Comment 10: Additional information is needed to support the conclusion that use of interim treatment measures before the completion of the SWPF is consistent with removal of highly radioactive radionuclides to the maximum extent practical.

SRS Response: This response evaluates and compares costs and benefits associated with three different cases and demonstrates that the salt waste disposition strategy described in the Draft Section 3116 Determination Salt Waste Disposal Savannah River Site, DOE-WD-2005-001, (WD) is the most cost effective case and the case that will provide the lowest overall risk to the site worker and to the general public. Additional details concerning the evaluation performed in response to this RAI comment can be found in “Cost and Benefit Evaluation for Three Salt Waste Treatment Cases at SRS” (d’Entremont et al. 2005).

Figure 12-1: Representation of Cases 1 Through 5

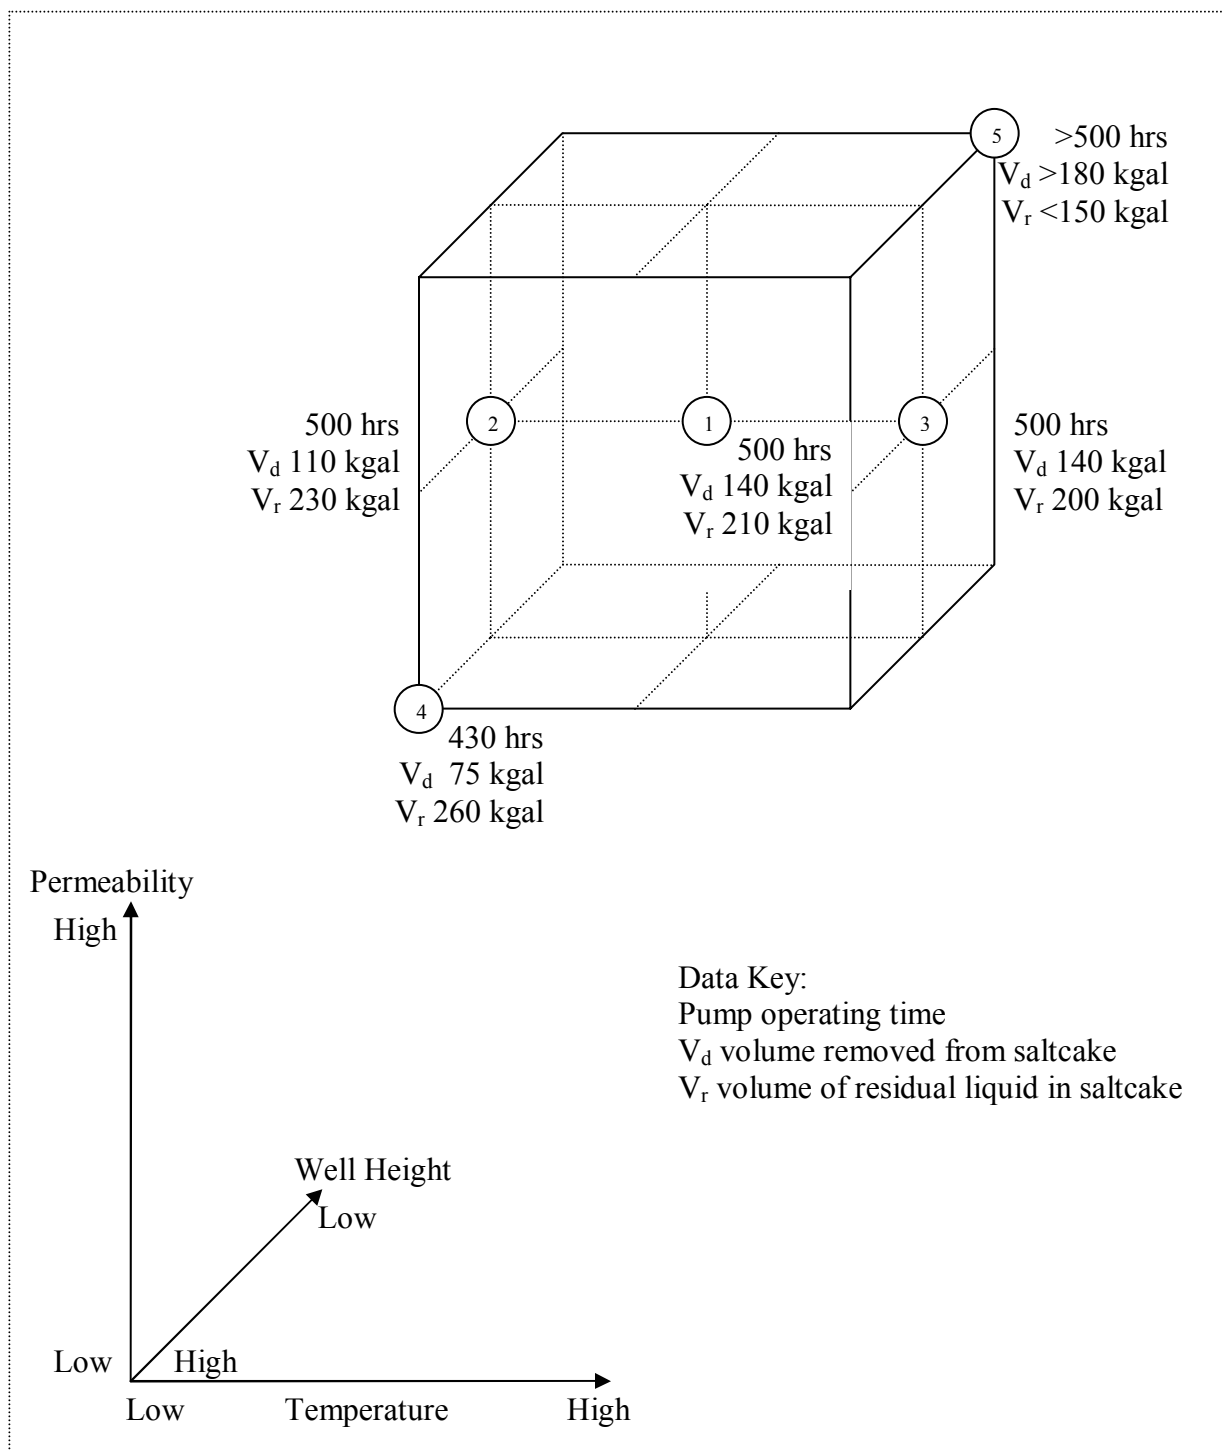
Comment 12: Additional information about the selection and optimization of treatment steps in the DDA treatment process and the selection of waste for DDA processing is necessary to support the conclusion that highly radioactive radionuclides have been removed to the maximum extent practical.

- 1) Factors that affect the amount of sludge entrained in the DDA waste, and efforts to optimize the process to minimize the amount of entrained sludge.
- 2) Alternative deliquification technologies that were evaluated and the expected removal efficiencies of highly radioactive radionuclides by those technologies. The response should address whether any technologies, such as vacuum techniques, that have been employed with some success at other sites (e.g., Hanford) were considered.

This response also should address the potential effects of differences in the porosity and pore structure of saltcake in different tanks and the potential effects of these differences on the success of the deliquification processes.

Figure 12-1 and Figure 12-2 provide the cases included in the analysis and the relationships between each possible variation. These figures also show the key results of each case. The cases were split into two groups that varied three parameters in order to simplify interpretation. The cube represents the three parameters varied between each set of cases. The axis for each dimension of the cube represents the range of variation expected or known for each parameter. The orientation of the range of values, i.e., high to low, was arranged such that the bottom front left corner represents the least aggressive, least favorable property combination. This combination would be expected to be the least residual liquid, the slowest rate, and, perhaps, the least volume removed. The upper back right corner represents the most aggressive, most favorable property combination.

The results depicted in Figure 12-1 and Figure 12-2 show comparable hydraulically equivalent endpoints, i.e., equivalent hydraulic pressure. The results depicted in the figures were pulled from the case runs when approximately 1 gpm interstitial liquid flow rate is achieved. Continuing to remove liquid in any case will produce a lower residual liquid in the saltcake, but this part of the removal curve also represents the least productive portion of the operation.

Figure 12-1 shows that the time to reach the end state changes relatively little compared to the dramatic variation in removed and residual volumes. Two of the three axis parameters, well height and temperature, can be controlled to some degree by the design of the operation. The variation in intrinsic permeability results in the most variation. Notice that the case with the least residual will take longer and produce more removed liquid volume even though the same stopping point is achieved.
